**Marion County  
Board of County Commissioners**

**PLANNING & ZONING SECTION  
STAFF REPORT**

<b>Hearing Dates</b>	<b>P&amp;ZC Date: 11/24/2025</b>	<b>BCC Date: 12/16/25</b>
<b>Case Number</b>	251209ZP	
<b>CDP-AR</b>	33384	
<b>Type of Case</b>	<b>Rezoning:</b> from General Agriculture (A-1) to Planned Unit Development (PUD)	
<b>Owner</b>	Linda Capozzoli	
<b>Applicant/Agent(s)</b>	Mastroserio Engineering, Inc.	
<b>Street Address / Site Location</b>	7317 SW 80 <sup>th</sup> St Ocala 34476	
<b>Parcel Number</b>	35460-039-00	
<b>Property Size</b>	±19.75 acres	
<b>Future Land Use</b>	Low Residential (LR)	
<b>Zoning Classification</b>	General Agriculture (A-1)	
<b>Overlay Zone/Scenic Area</b>	Urban Growth Boundary (UGB), Secondary Springs Protection Overlay Zone (SSPOZ)	
<b>Staff Recommendation</b>	<b>APPROVAL WITH CONDITIONS</b>	
<b>P&amp;ZC Recommendation</b>	<b>APPROVAL WITH CONDITIONS (4-2)</b>	
<b>Project Planner</b>	Erik Kramer, Planner	
<b>Historic/Related Case(s)</b>	Concurrent 25-S15 – Small-scale comprehensive plan map amendment from Low Residential (LR) to Medium Residential (MR)

**Figure 11**

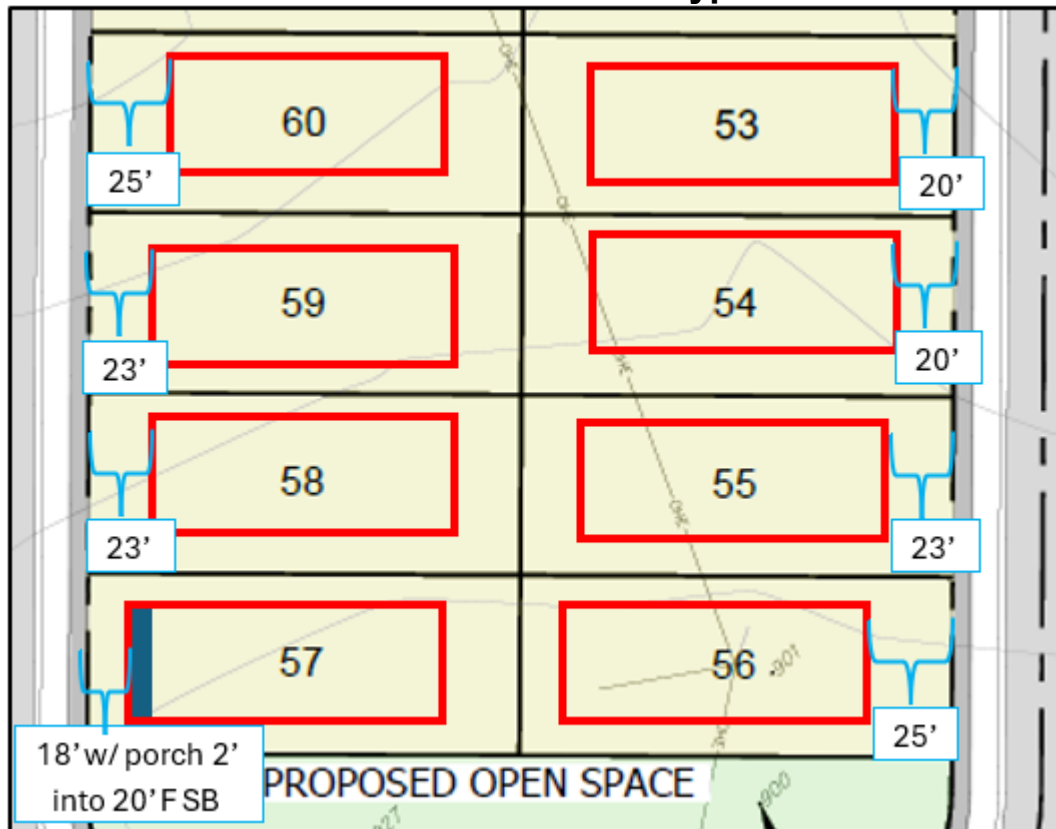
**Analysis:** Staff find the PUD proposes its own setbacks and height limitations on the PUD plan sheet. Table 3 of this report shows the proposed setbacks and height limits. The proposed minimum lot size and minimum side and rear setbacks are lower than typical Single-Family Dwelling (R-1) zoning for detached single-family development and lower than the A-1 zoning present in the surrounding. The proposed single-family uses are compatible with existing uses in the area; however, the proposed lot sizes and minimum yard sizes differ from the character of the surrounding area. The existing character is small farms and residential estates on larger lots to the north, east, and south with mature tree canopies. To the west is Hibiscus Park Unit 1 and 2, which were platted with smaller lots; however, the existing parcel configurations are large lots with mature vegetation on most of the lots. To match and enhance the character of the area, staff recommends the following conditions pertaining to shade trees and front setback variation (setback typical example shown in Figure 11):

- *Each residential lot shall provide a minimum of two (2) shade trees. The shade trees will be located in a way to provide a cohesive street canopy and minimally interfere with utilities. The developer's team will coordinate the tree species and tree placement with the County's Landscape Architect, Growth Services Director, and Utilities Director, or their designees.*
- *With any group of three (3) consecutive dwelling units along the same street frontage, the front building line of each dwelling shall vary by at least two (2) feet and no more than five (5) feet from the adjacent unit. No more than two (2) consecutive dwellings may have the same front setback. The pattern of setback variation shall be shown on the improvement plan during development review and maintained through building permit review.*

8. With any group of three (3) consecutive dwelling units along the same street frontage, the front building line of each dwelling shall vary by at least two (2) feet and no more than five (5) feet from the adjacent unit. No more than two (2) consecutive dwellings may have the same front setback. The pattern of setback variation shall be shown on the improvement plan during development review and maintained through building permit review.
